MONTGOMERY COUNTY HISTORIC PRESERVATION COMMISSION
STAFF REPORT

| Address: | 7403 Baltimore Ave., Takoma Park | Meeting Date: | 1/10/2024 |
| Proposal: | HVAC condenser installation | | |

Figure 2: The applicant provided this site plan for the proposed condenser location.

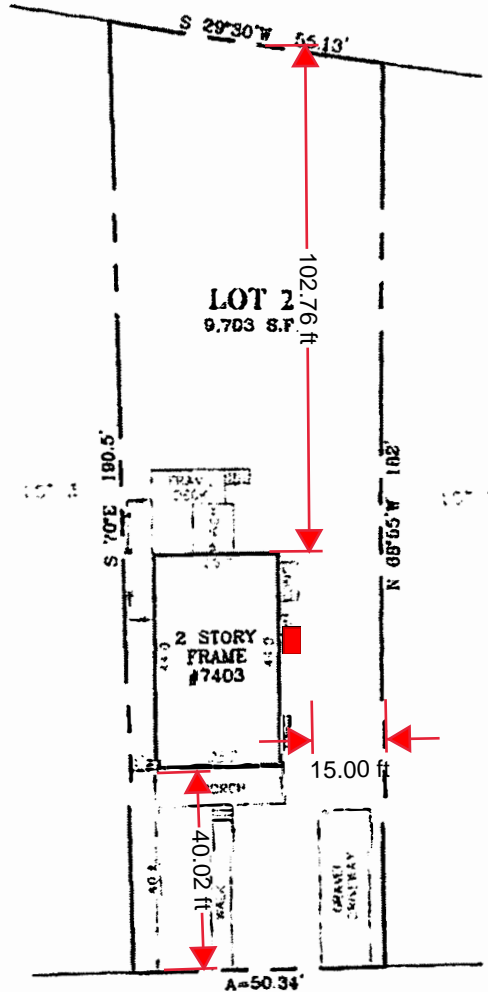
Staff supports the installation. It will have no material impact on the historic building and will be located on an inconspicuous side elevation. Based on the photos provided of the unit, it will not be readily visible and will be set back approximately 75 feet from the right of way. Staff seeks more details from the applicant before the plans can be certified. First, the applicant must provide staff with the dimensions of the unit to confirm it is of a compatible size for the location and it will not be prominently visible. Staff also seeks information on the size and material of the condenser's pad and how far away it will be from the residence's foundation.

1. Applicant shall provide staff with the dimensions of condenser unit for review before the plans will be stamped.
2. Applicant shall provide staff with the dimensions and material of the condenser's pad and its distance from the building foundation before the plans will be stamped.
